15-17 West Lancaster Avenue, Ardmore Commercial Historic District

25-20

Preliminary Consultant Review

15-17 West Lancaster Avenue, Ardmore Historic District

Wall of 17 W. Lancaster Ave.

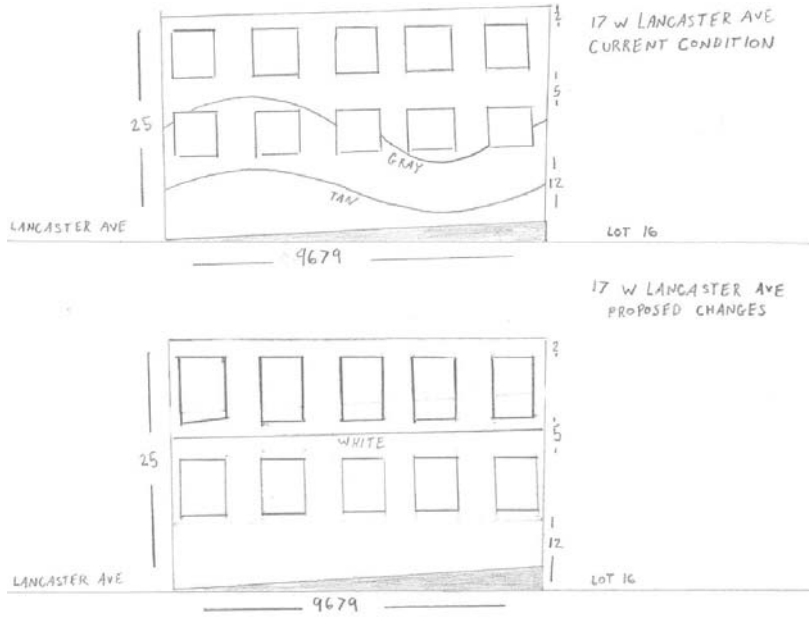
- Proposed renovations include repointing areas of the brick walls where needed, painting over the existing waves of tan and gray paint with a full one-story height of white paint to provide a “blank canvas”; installation of multiple mural paintings on canvas to be applied to the white field, installation of string lights crisscrossing down the pedestrian alley, and adding bistro tables and planters.

- Upgrades to the decorative elements of the pedestrian alley are warranted and improve the public interest and safety in the area. Lighting of more constrained spaces such as this is always a good idea for public safety, and string lights are a common and pleasing method of doing so with minimal impact on the structures. Public art on open horizontal surfaces is also a positive element in historic districts, but in the Ardmore Historic District where painting the predominant facades of red brick is not appropriate, creating a large white field for artwork would not be appropriate either. Given the existing painted brick surface, it would be most appropriate to either test the potential removal of the existing paint, repaint the existing colors as a means of maintenance (employing appropriate coatings for the masonry application), or creating the desired monolithic “field” of the whole first story by applying an appropriate coating in a red-brick color so that it blends in with the existing brick, but still provides a uniform background for installed artwork.

- The proposed artwork (presuming the submitted imagery is currently functioning as placeholders) should be reviewed by the HARB when developed.

Given the considerations noted above, we recommend approval of this application in accordance with Standards 7, 9 and 10.
